**Creation of Access Ramp, St. Heddass, Egton Bridge**

Project:  
Access Improved to New Dining Hall & Classroom.  
St. Heddas RC Primary School, Egton Bridge

Drawing:  
Proposed Floor Plans & Elevations

Proj. No.:	Status:	Dwg. No.:	Rev:
1916	PL	002	B

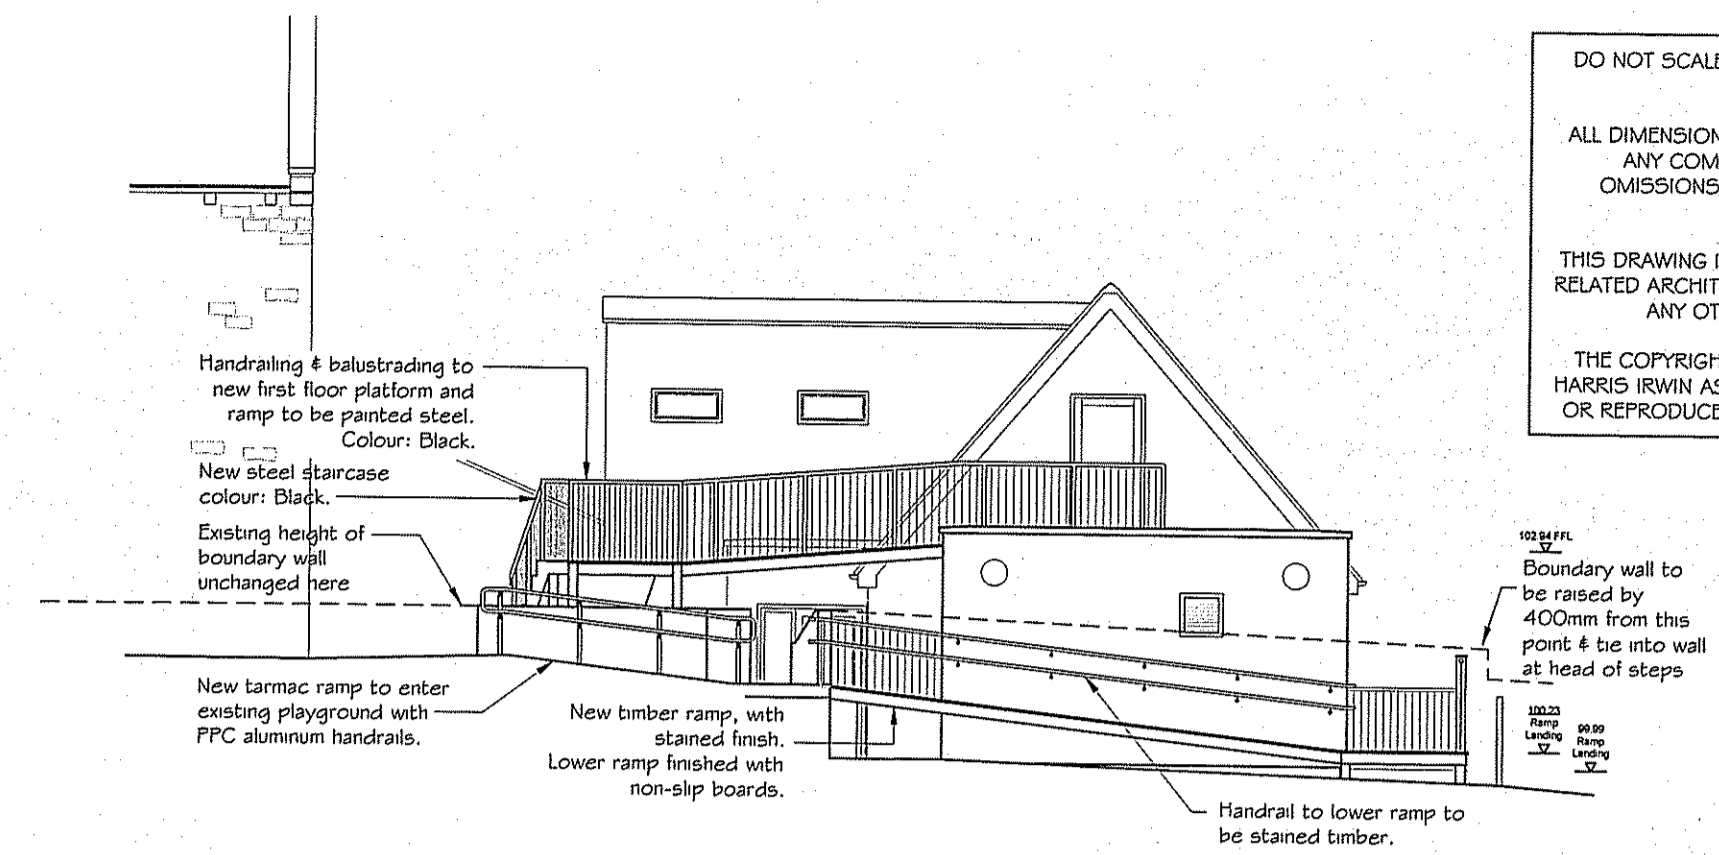
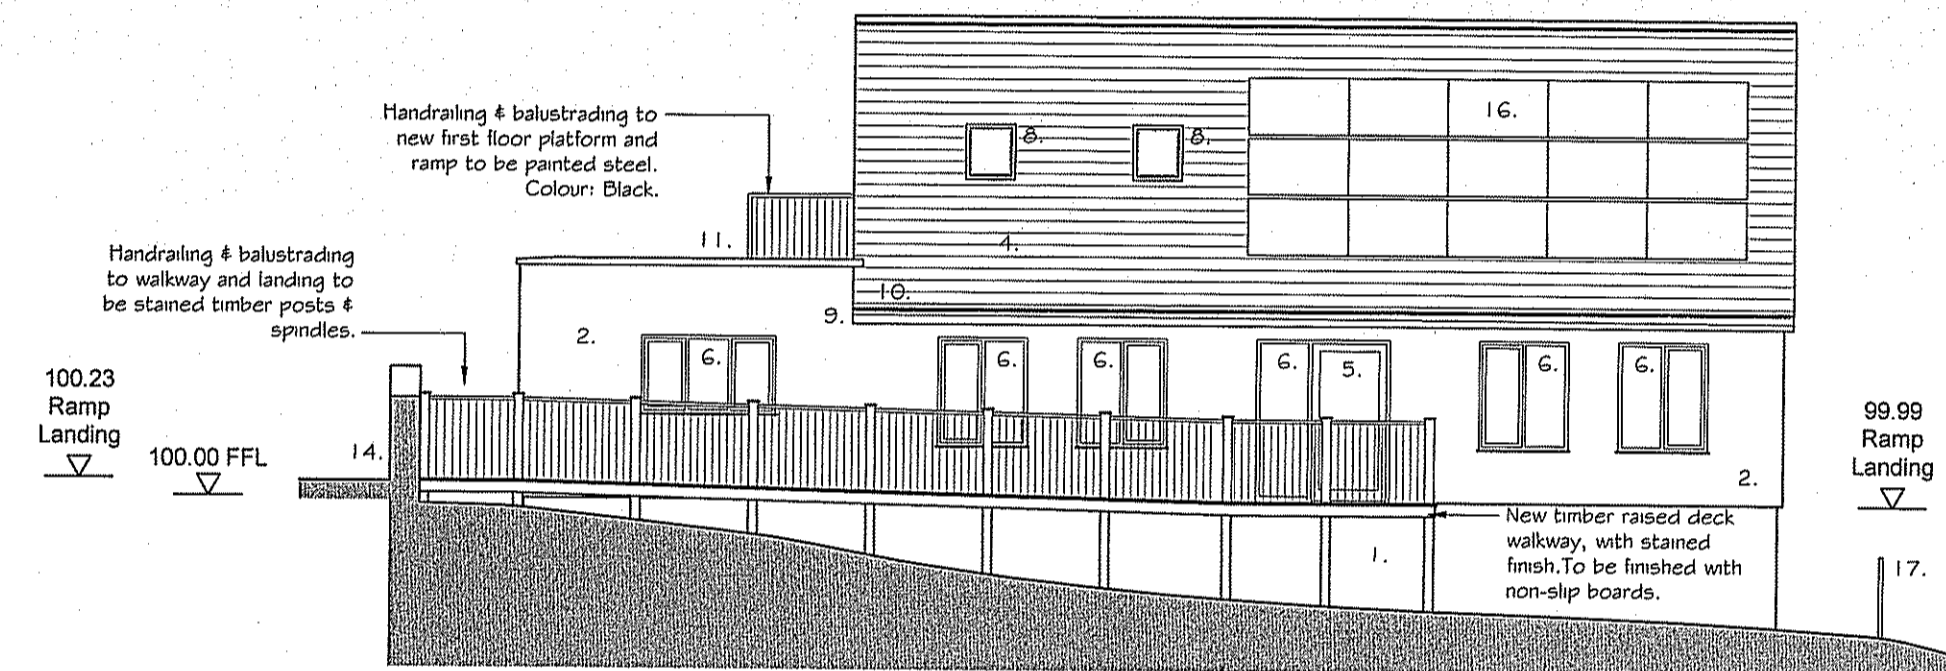
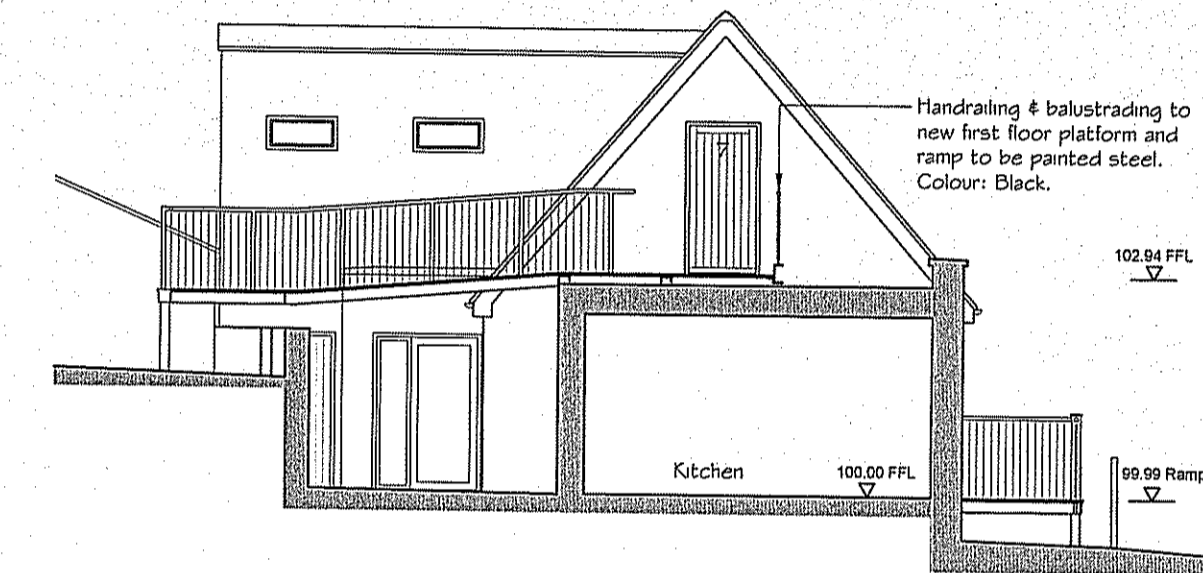
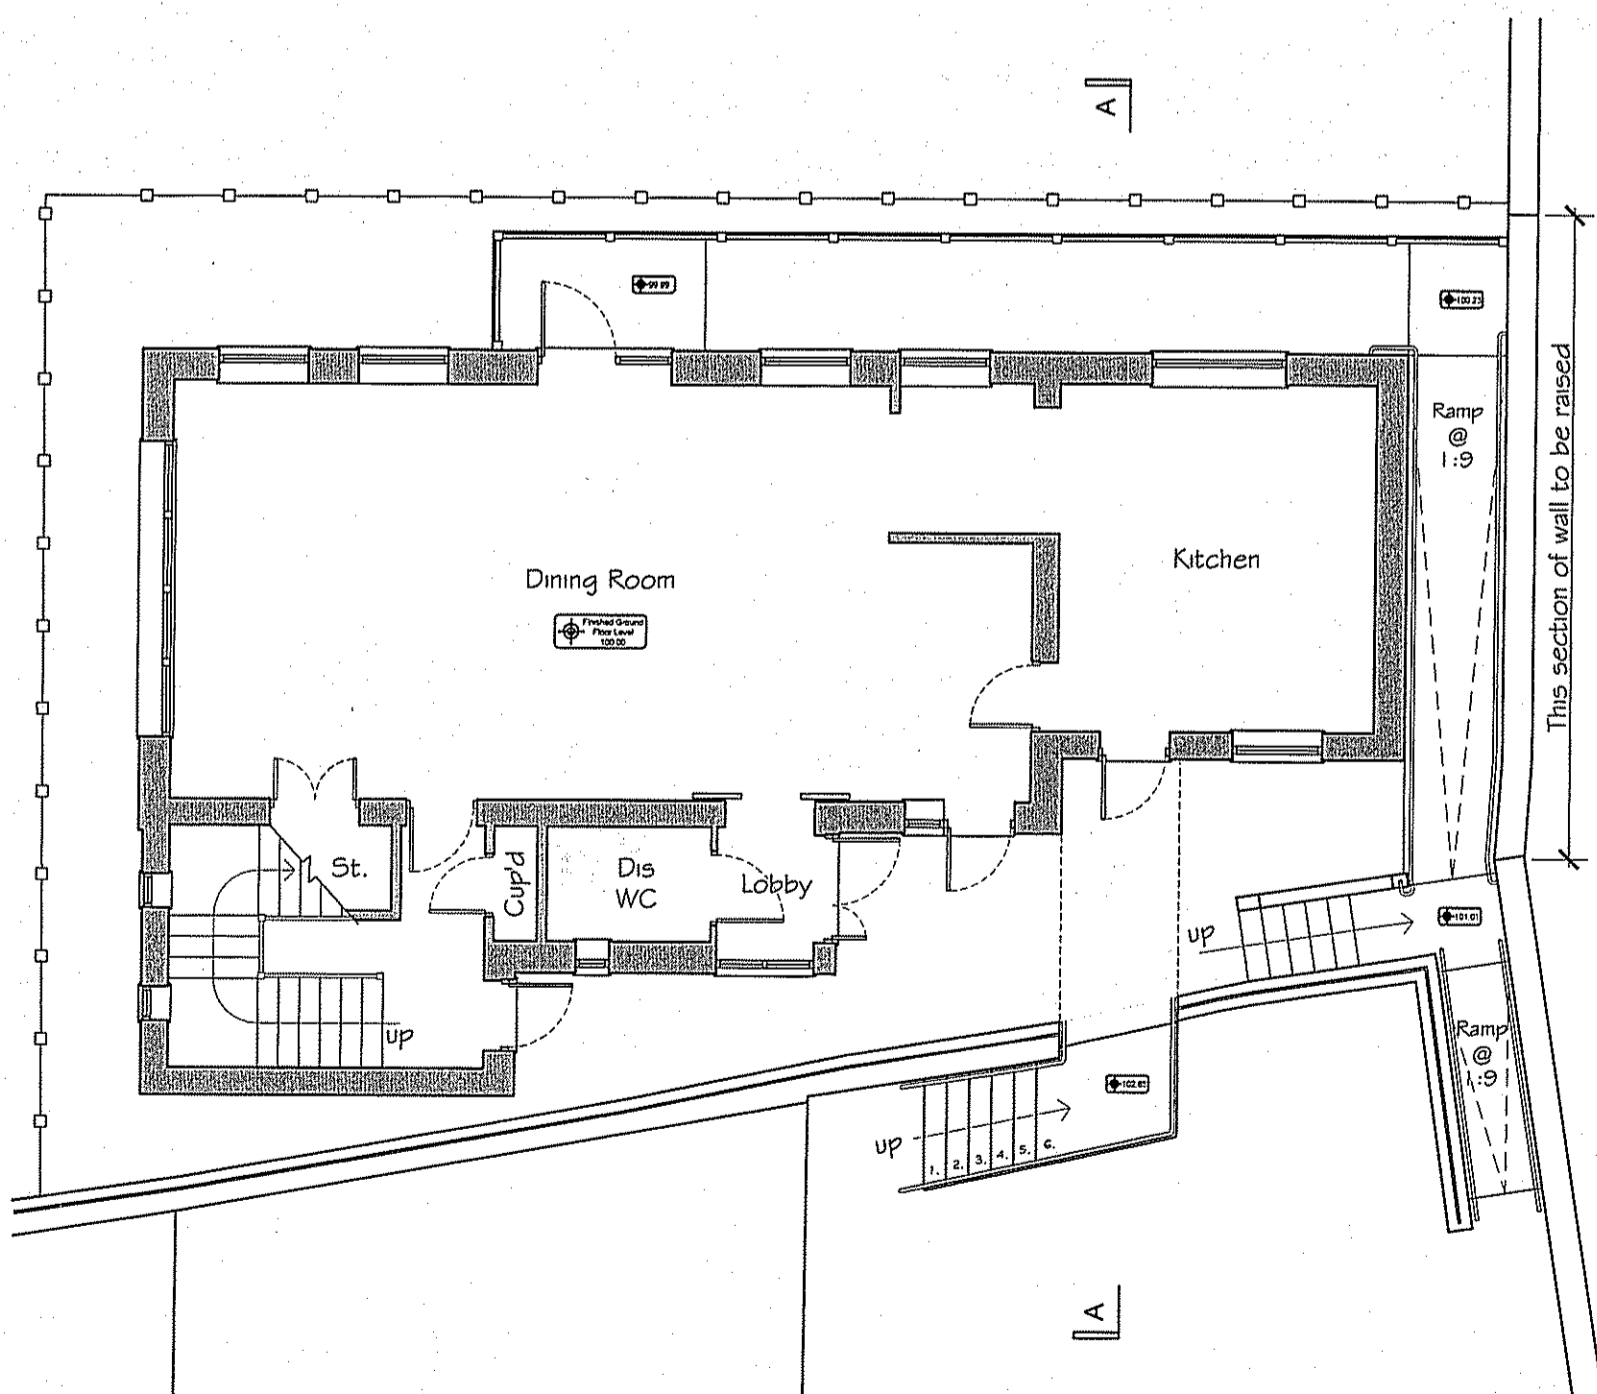
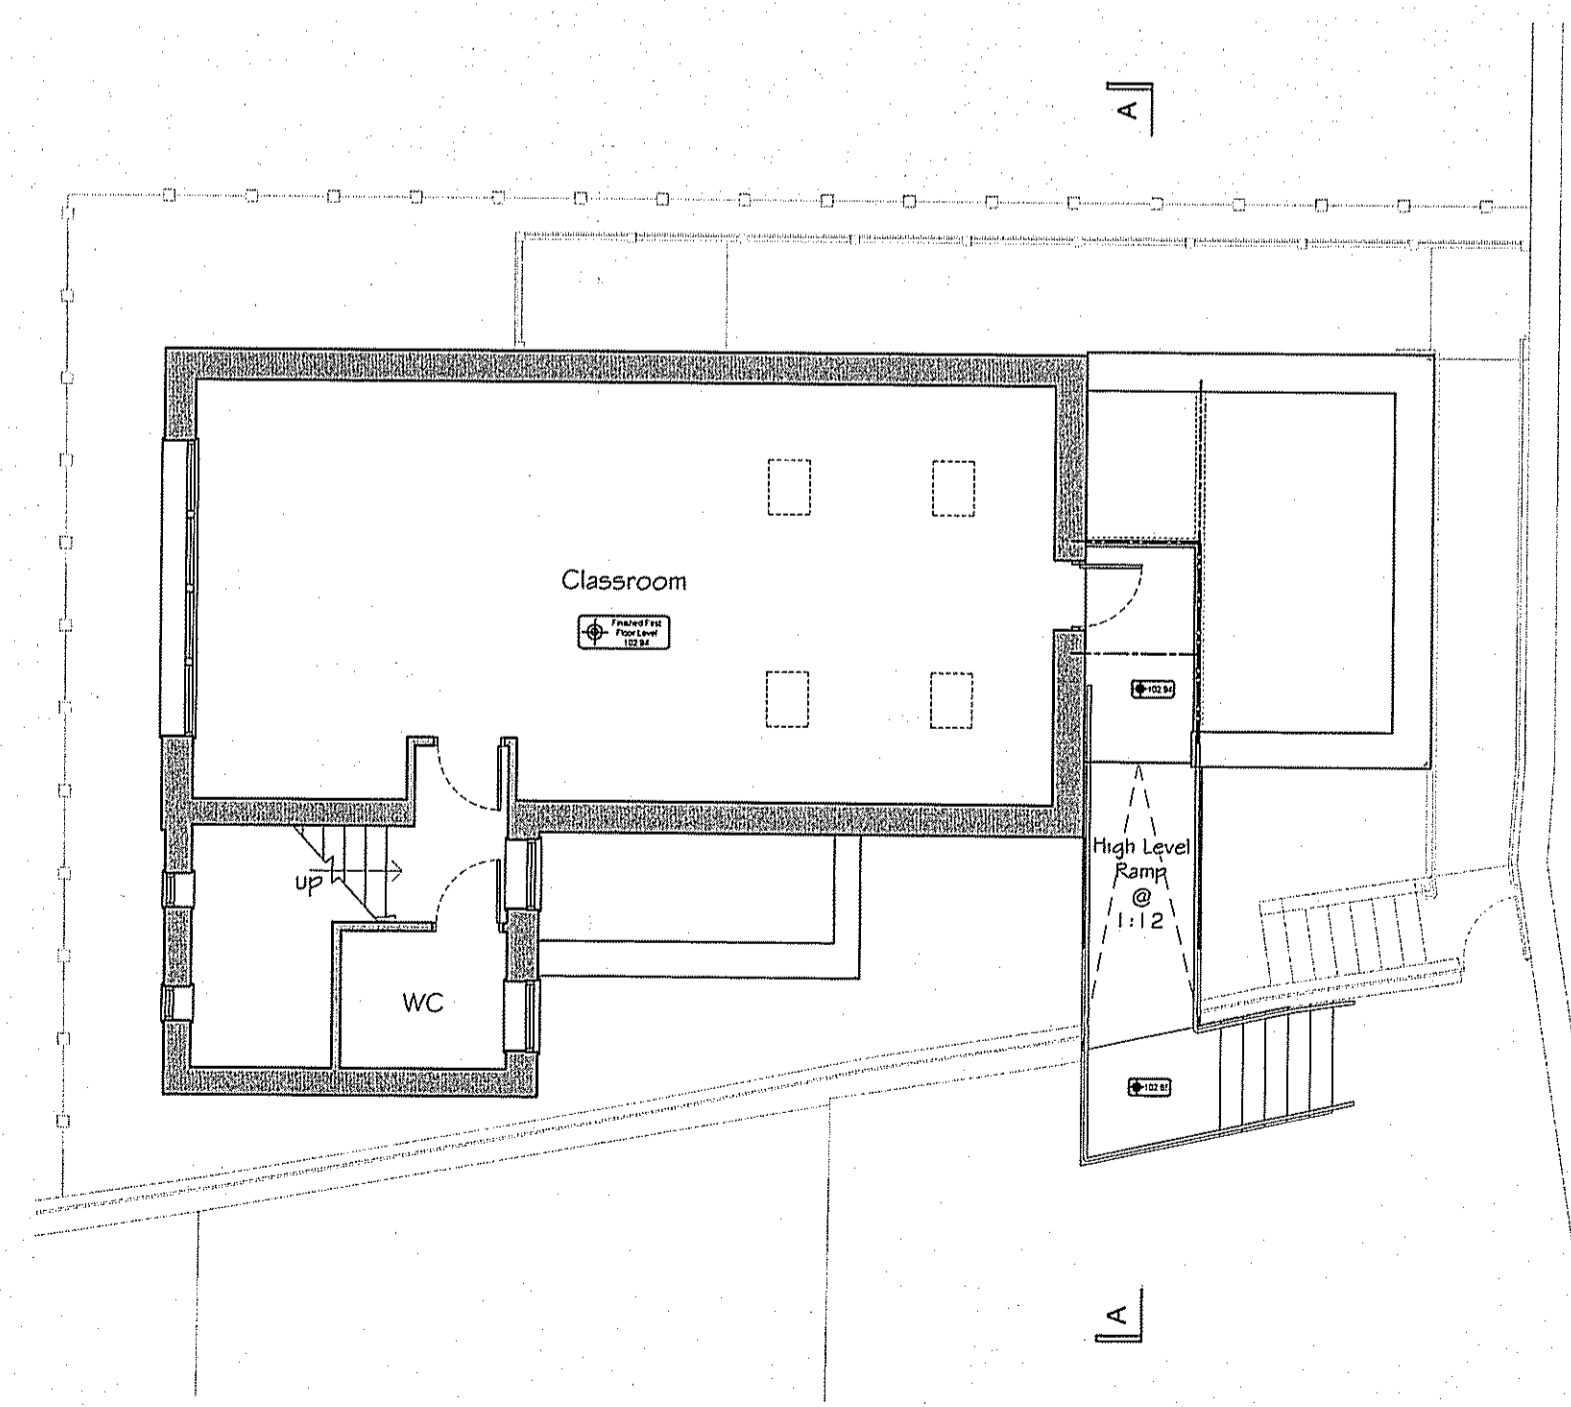
Last time we spoke we discussed the possibility of raising the boundary wall a little, pro-rata to the height gained by the ramp along the back of the Dining Room.

Further to this please find attached revised drawings where we have adjusted the gradient of the ramp such that the rear corner is 382mm higher than the present level, we have lifted the wall here by 400mm to compensate. This shallowing of the ramp along the rear has necessitate us steepening the remainder of the ramp to minimise the impact on the playground.

We have also flipped the steps to the first floor around as requested.

Rev	Date	Description	By
B	28-10-15	Proposals revised following planners comments boundary wall raised as discussed.	JHT
A	27-02-15	Issued for Planning Permission	MFT
